SOUTH VALLEY WATER RECLAMATION FACILITY
PROJECT 4D
WEST JORDAN, UTAH

MECHANICAL
BIOREACTOR NO. 4 AIR
DIFFUSER SYSTEM PLAN

SOUTH VALLEY WATER RECLAMATION FACILITY		
WEST JORDAN UTAH		
THIS DRAWING IS THE PROPERTY OF SANITAIRE AND IS SUBMITTED IN CONFIDENCE. IT IS NOT TO BE REPRODUCED, COPIED OR DUPLICATED WITHOUT PERMISSION OF SANITAIRE.		
BIOREACTOR 1-4 STRUCTURAL, DROPLEGS & MANIFOLDS KEY PLAN		
ITT Corporation		
SANITAIRE® BROWN DEER, WISCONSIN 53223 ABJ®		
DRAWN BY: MRL	DATE: 12-4-07	DESIGN: NEW/REV
CHKD BY: MTR	DATE: 12-12-07	STD.
APPROV BY: DE	DATE: 12-13-07	SHEET: 2 OF 40
JOB: 07-67425		
S-2

BIOREACTOR 1-4
AERATION GRIDS
KEY PLAN

OX-7B
GRID TYPE 11
PLAN VIEW (42)

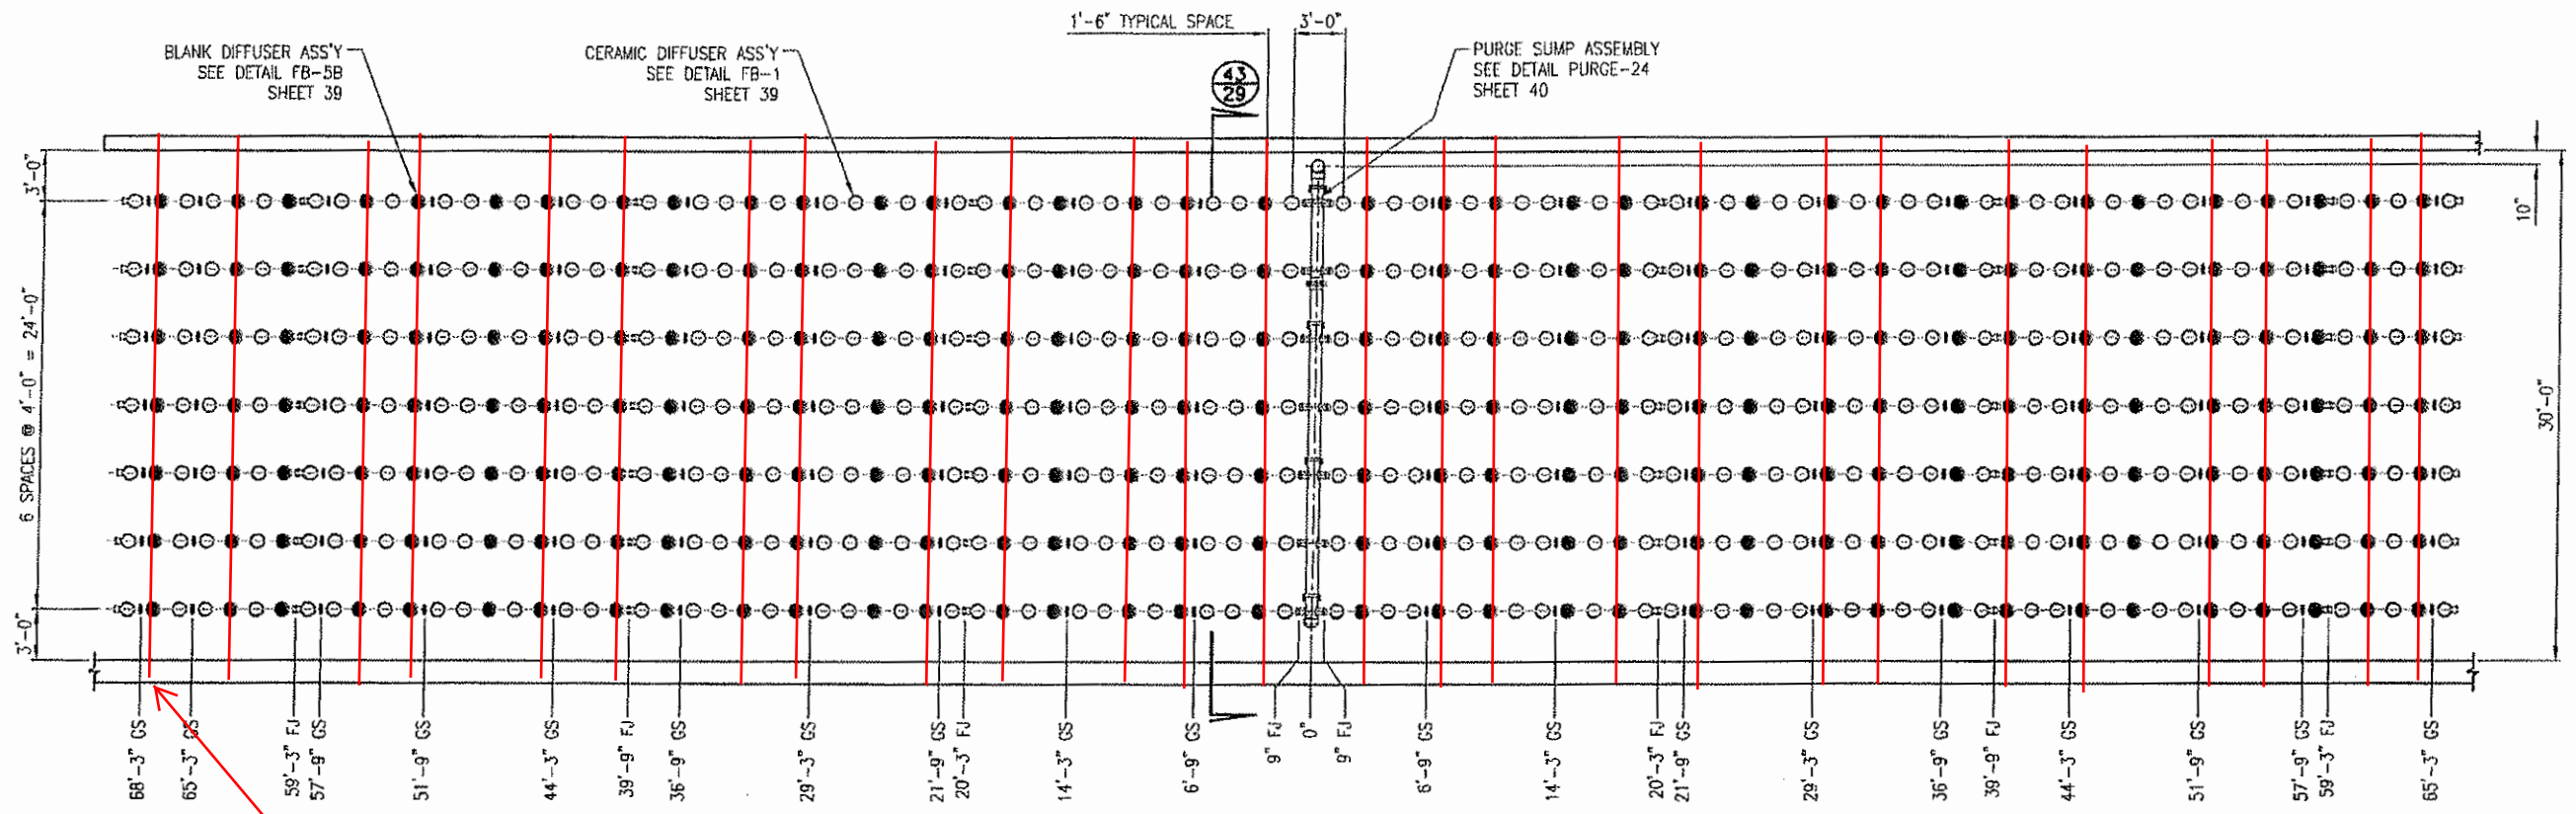
- 1) FOR BIOREACTOR 2: REMOVE AND REPLACE EXIST SSI EPDM/TEFLON MEMBRANE DIFFUSERS WITH NEW SSI EPDM/TEFLON DIFFUSERS. THERE ARE 378 EXISTING SSI DIFFUSERS IN THIS GRID. REMOVE PLUGS FROM EMPTY DIFFUSER HOLDERS, INSTALL PVC SUBPLATES AND ADD 182 SSI EPDM/TEFLON MEMBRANE DIFFUSERS WITH PVC RETAINER RINGS AND PVC SUBPLATES WHERE INDICATED BY RED LINES. FINAL MEMBRANE DIFFUSER COUNT IN THIS GRID IS 560.
- 2) FOR BIOREACTOR 3: REMOVE AND REPLACE CERAMIC DIFFUSERS WITH EPDM MEMBRANE DIFFUSER AND PVC SUBPLATES. REMOVE PLUGS FROM EMPTY DIFFUSER HOLDERS, INSTALL PVC SUBPLATES AND ADD 182 EPDM MEMBRANE DIFFUSERS WITH PVC RETAINER RINGS WHERE INDICATED BY RED LINES. FINAL MEMBRANE DIFFUSER COUNT IN THIS GRID IS 560.

OX-7B
GRID TYPE 12
PLAN VIEW (44)

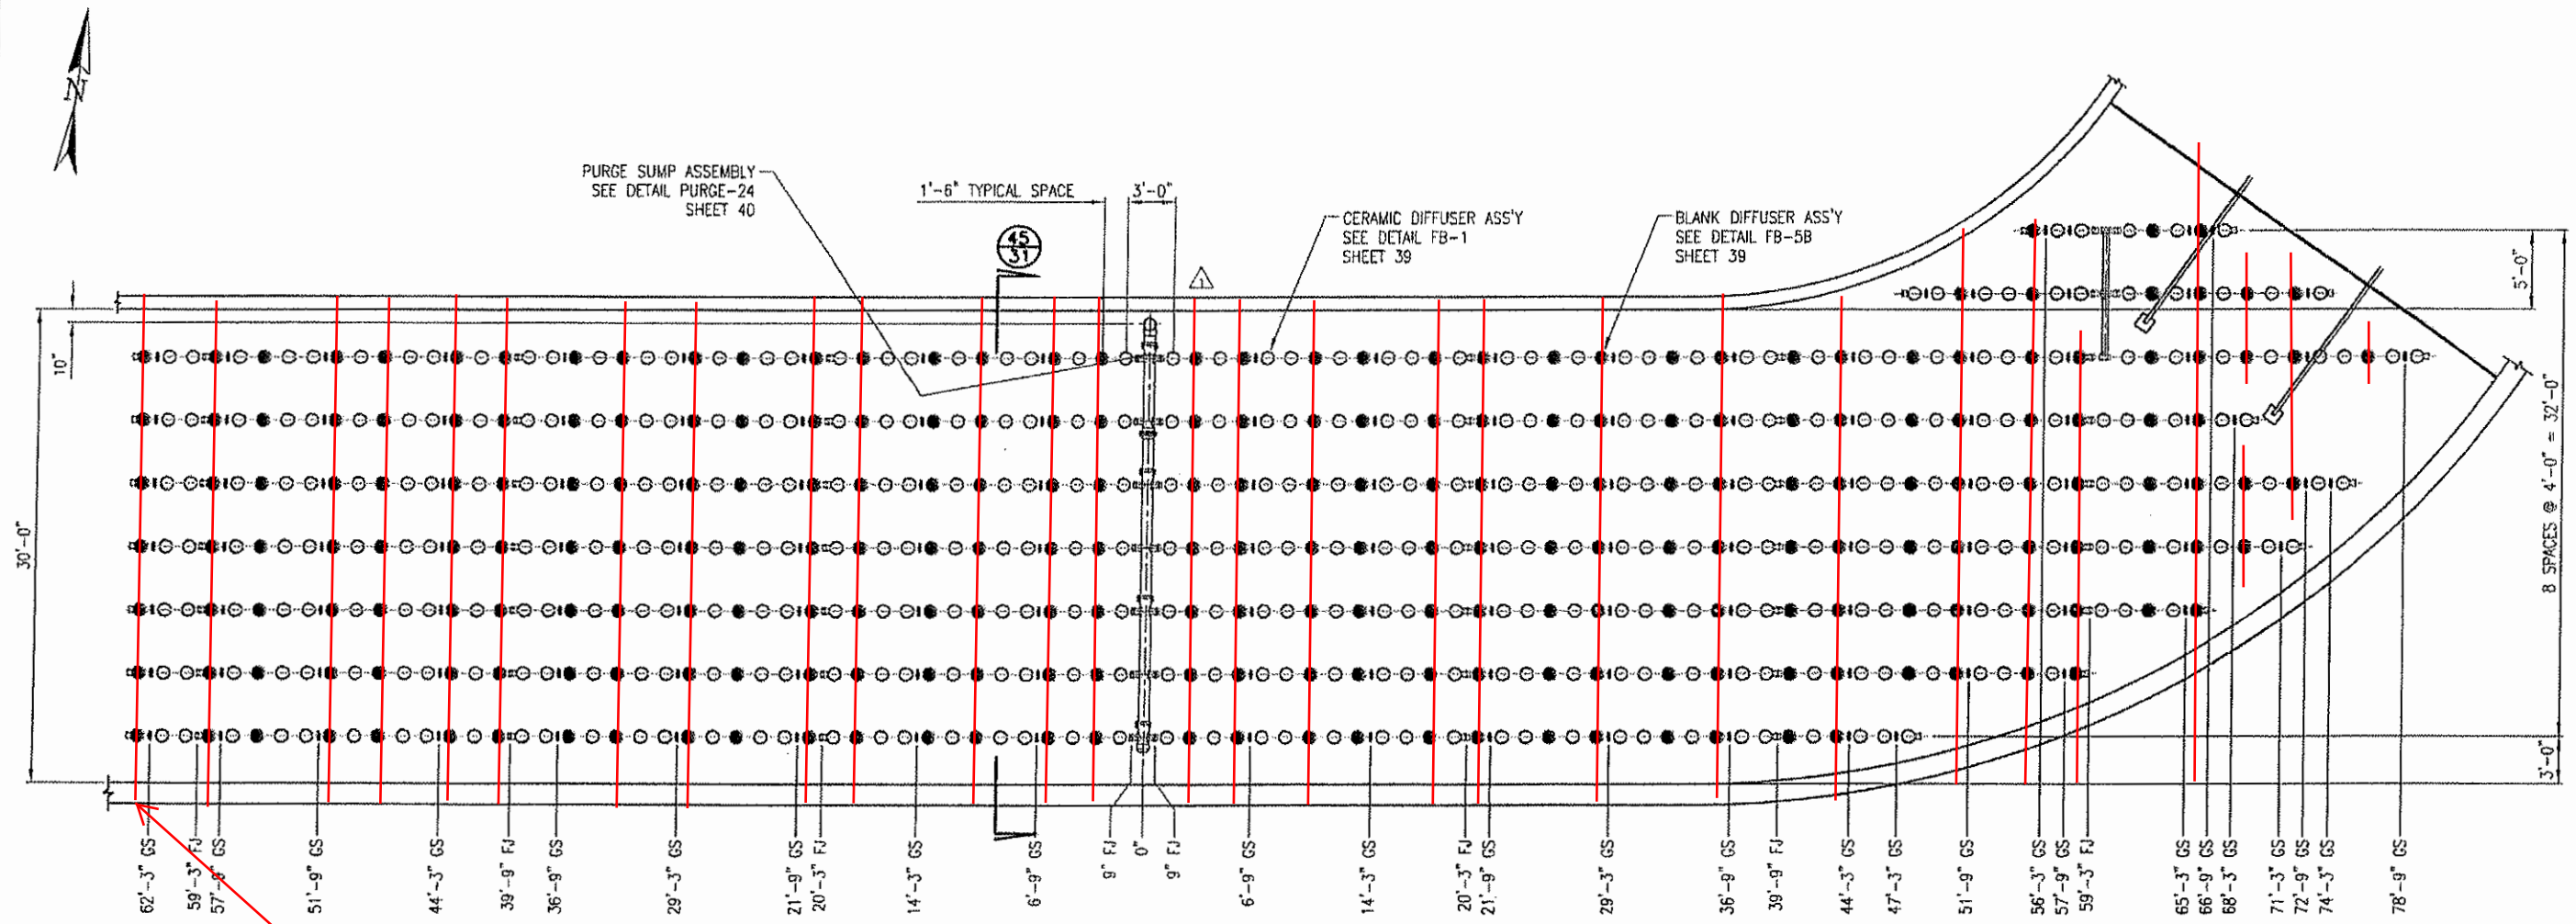
FOR THIS GRID:
1) REMOVE PLUGS FROM DIFFUSER HOLDERS, INSTALL PVC SUBPLATES AND ADD 183 (91 LEFT SIDE, 92 RIGHT SIDE) EPDM MEMBRANE DIFFUSERS WITH PVC RETAINER RINGS WHERE INDICATED BY RED LINES. TOTAL MEMBRANE DIFFUSER COUNT IN THIS GRID IS 561.
2) REMOVE AND REPLACE ALL OTHER CERAMIC DIFFUSERS WITH EPDM MEMBRANE DIFFUSER AND PVC SUBPLATES. TYPICAL BOTH BIOREACTORS.

OX-8
GRID TYPE 13
PLAN VIEW 47

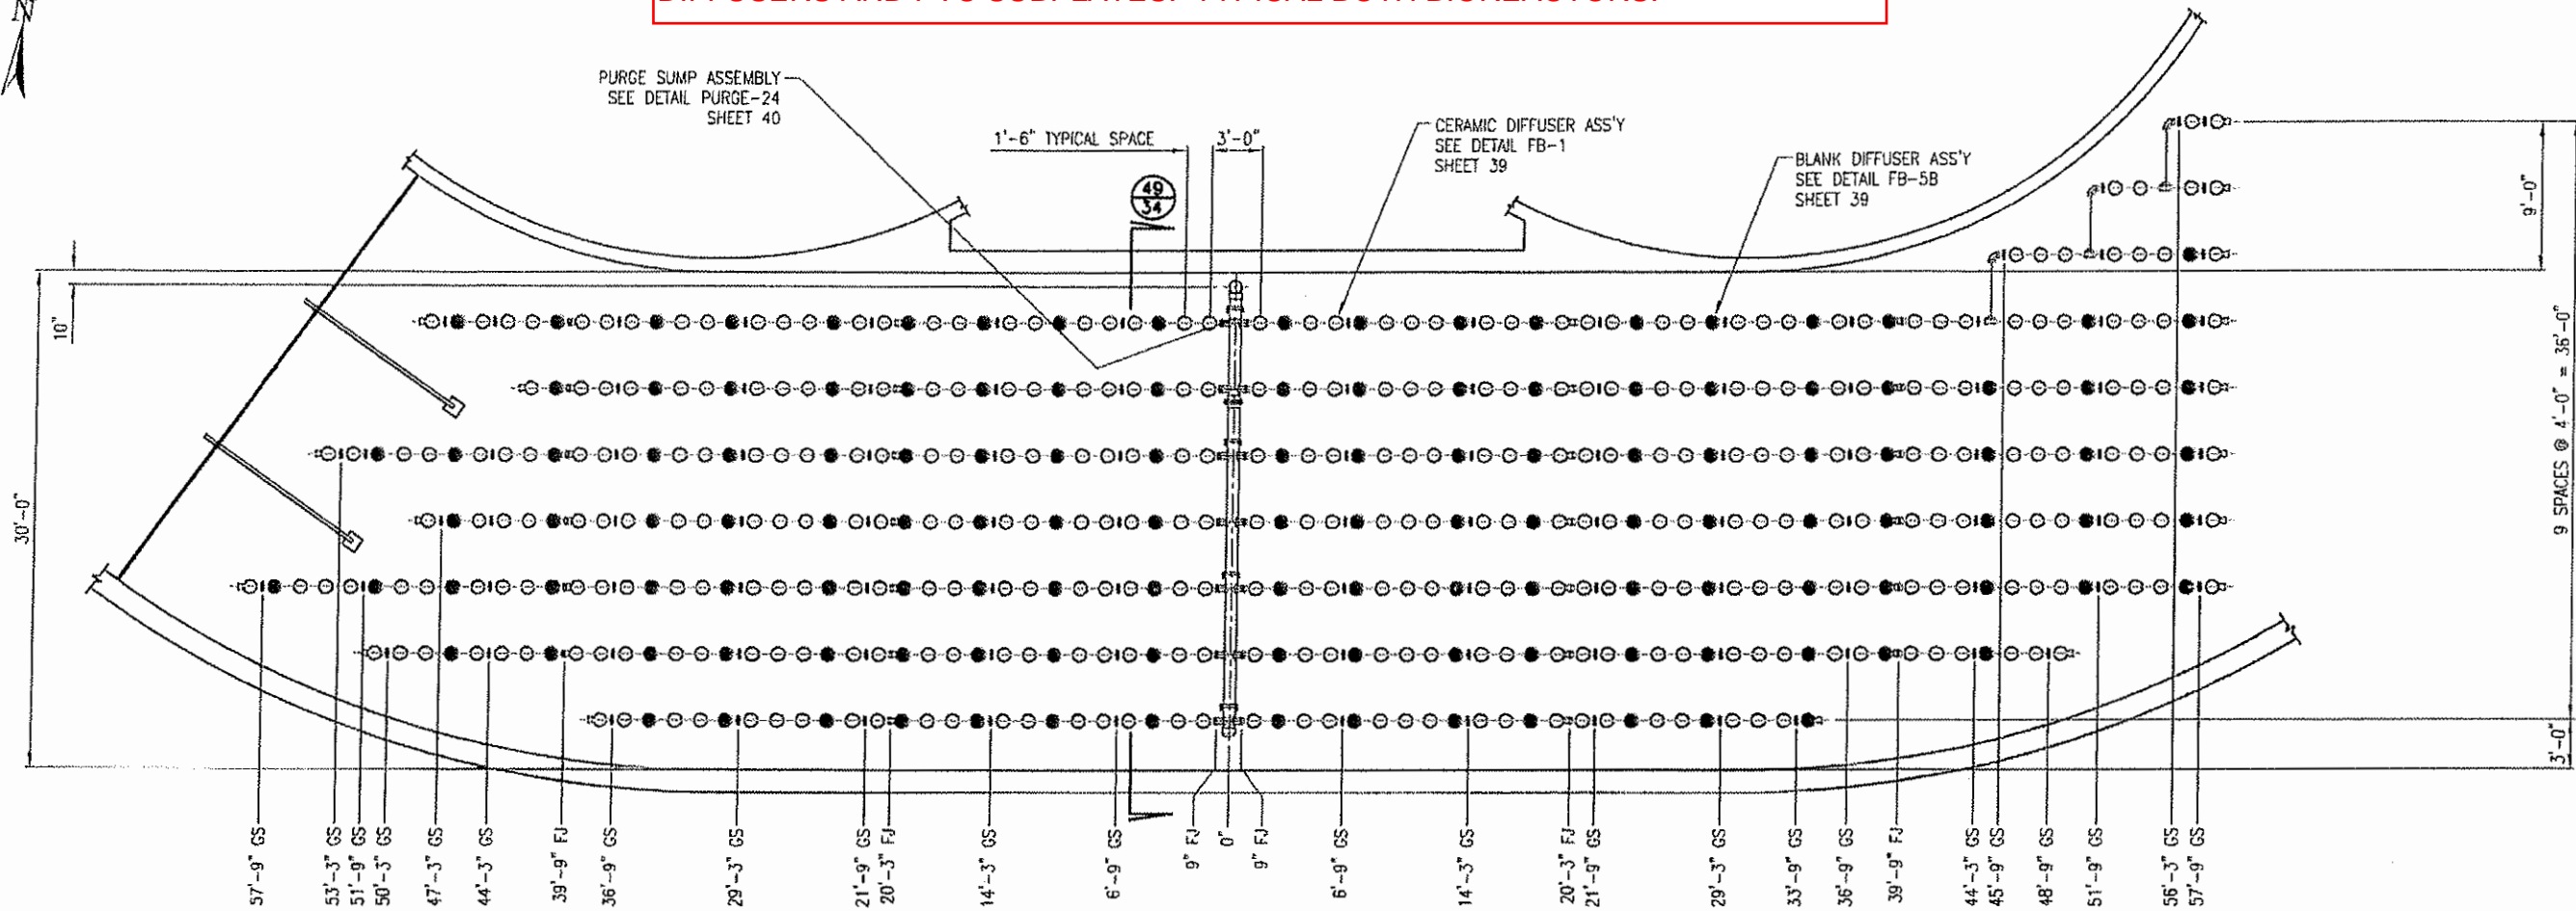
FOR THIS GRID:
REMOVE AND REPLACE ALL CERAMIC DIFFUSERS WITH EPDM MEMBRANE
DIFFUSERS AND PVC SUBPLATES. TYPICAL BOTH BIOREACTORS.

OX-8
GRID TYPE 14
PLAN VIEW (48)

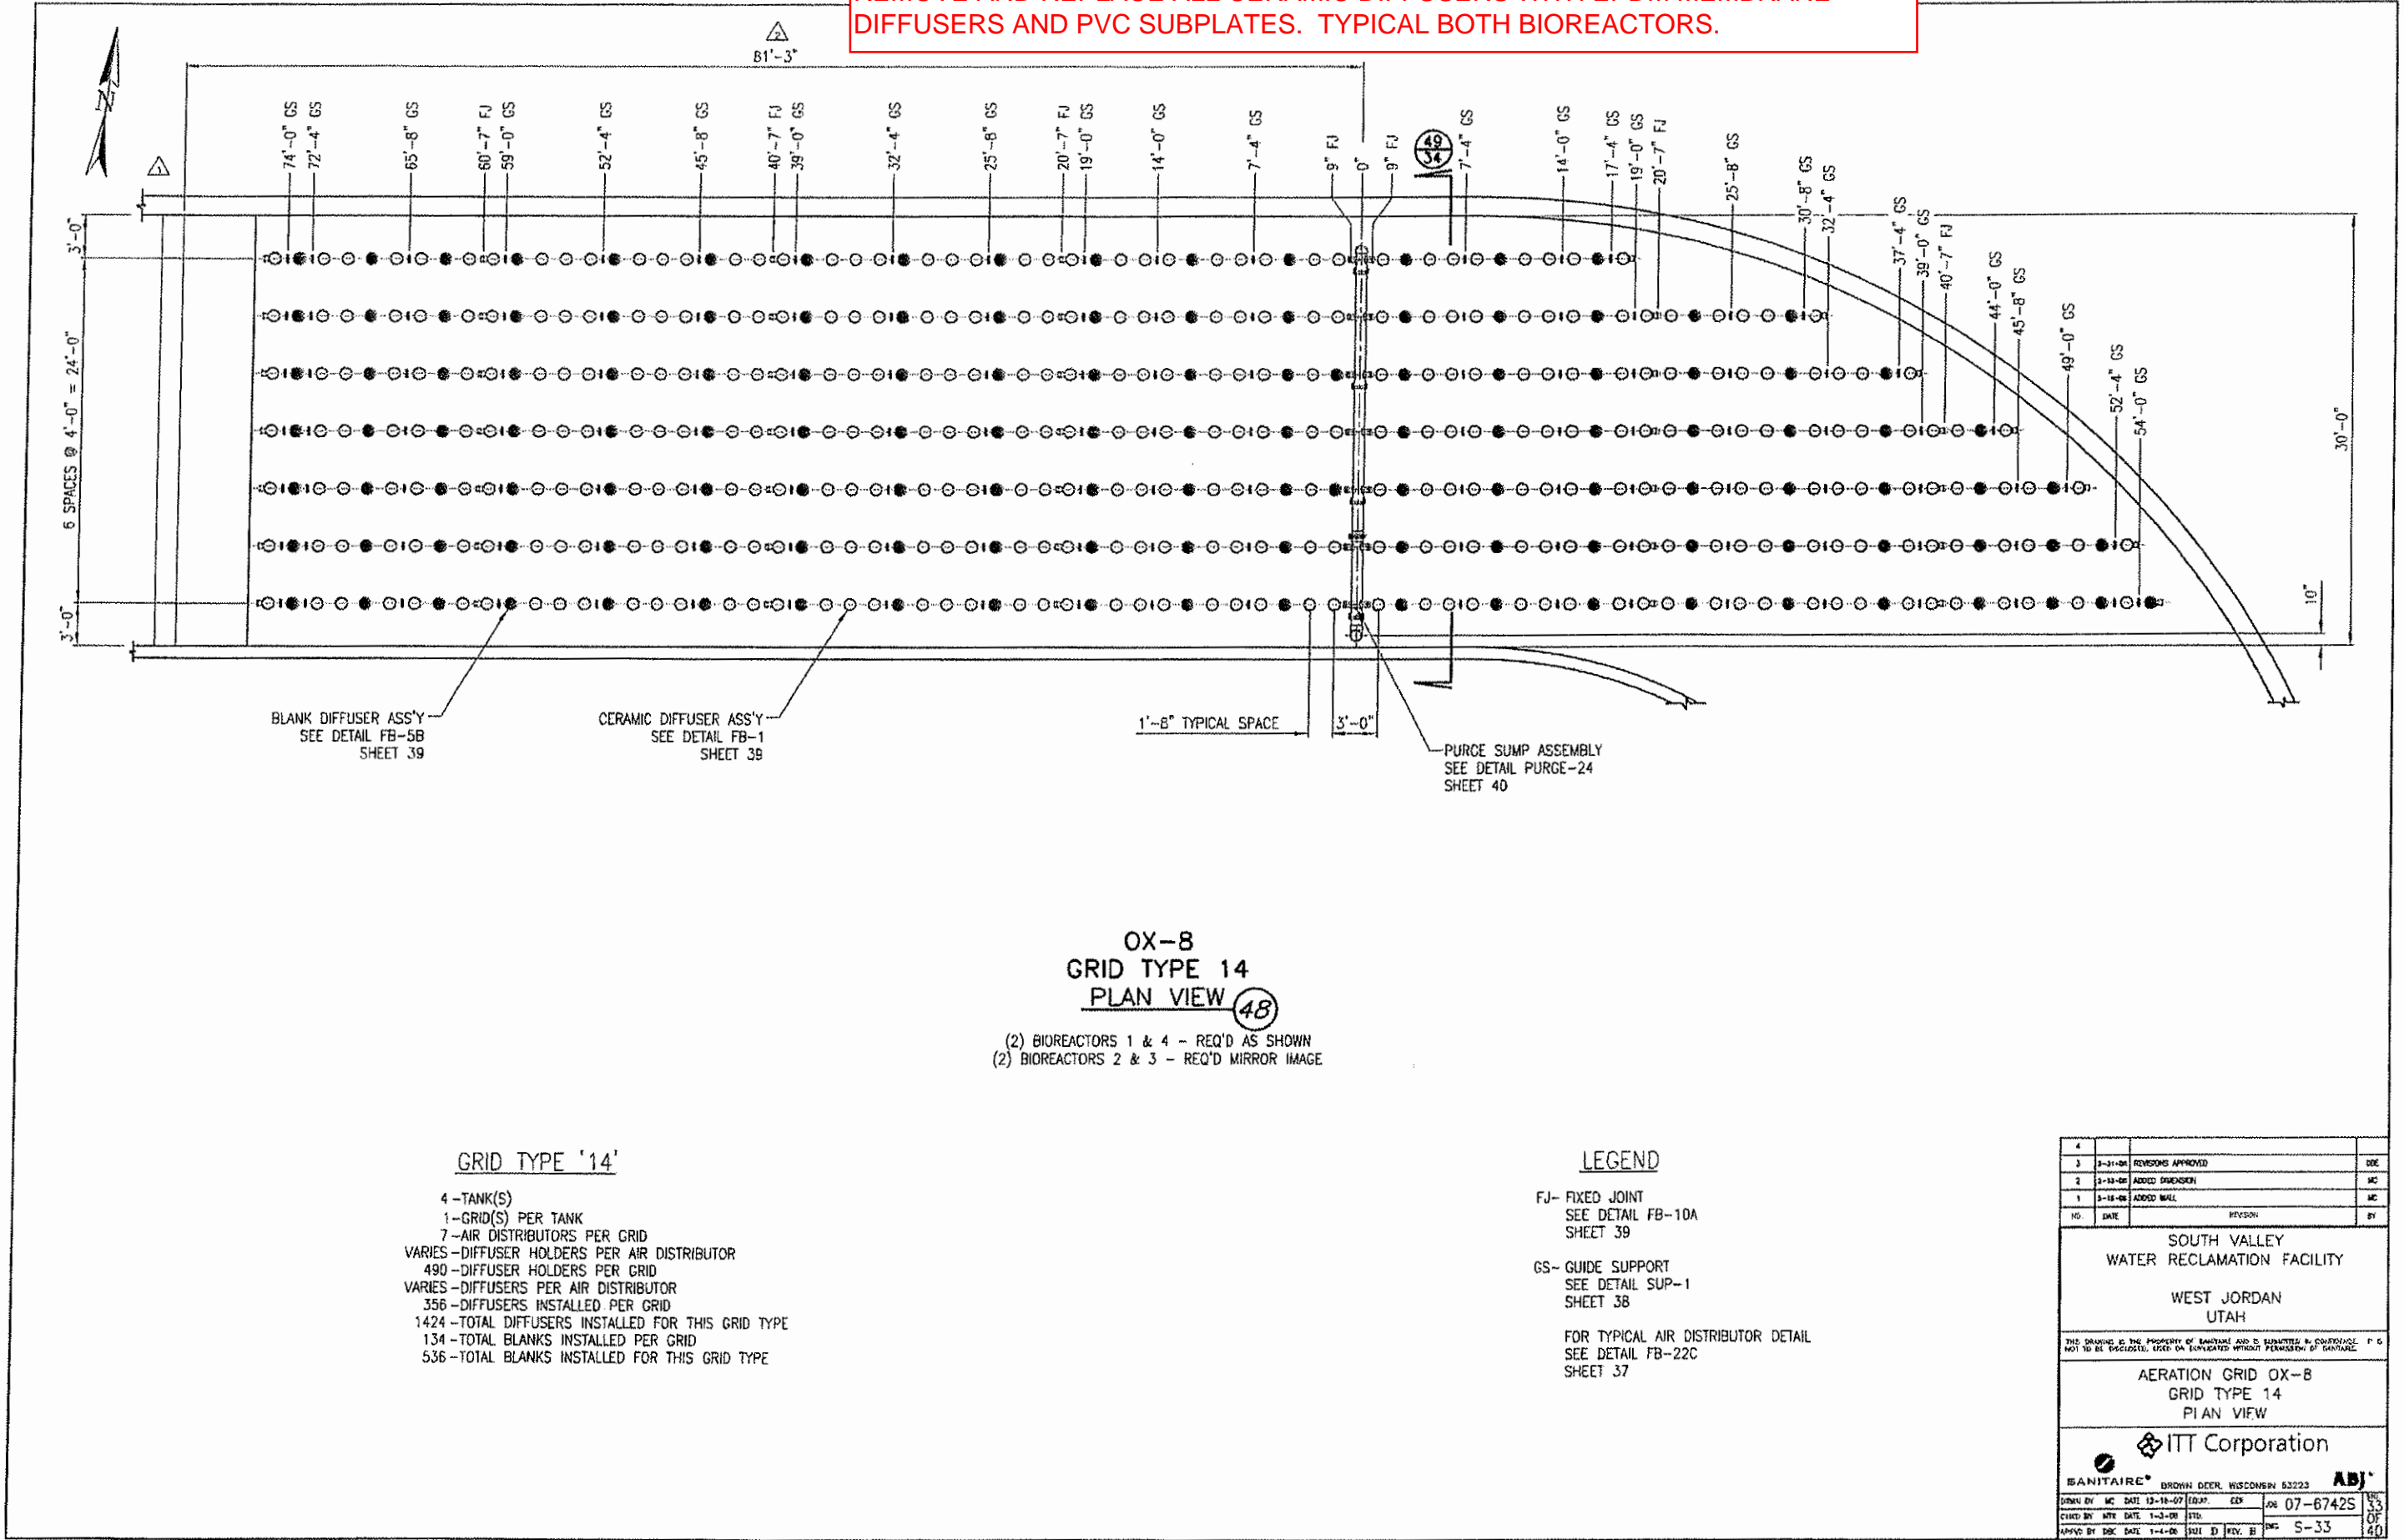
FOR THIS GRID:
REMOVE AND REPLACE ALL CERAMIC DIFFUSERS WITH EPDM MEMBRANE
DIFFUSERS AND PVC SUBPLATES. TYPICAL BOTH BIOREACTORS.
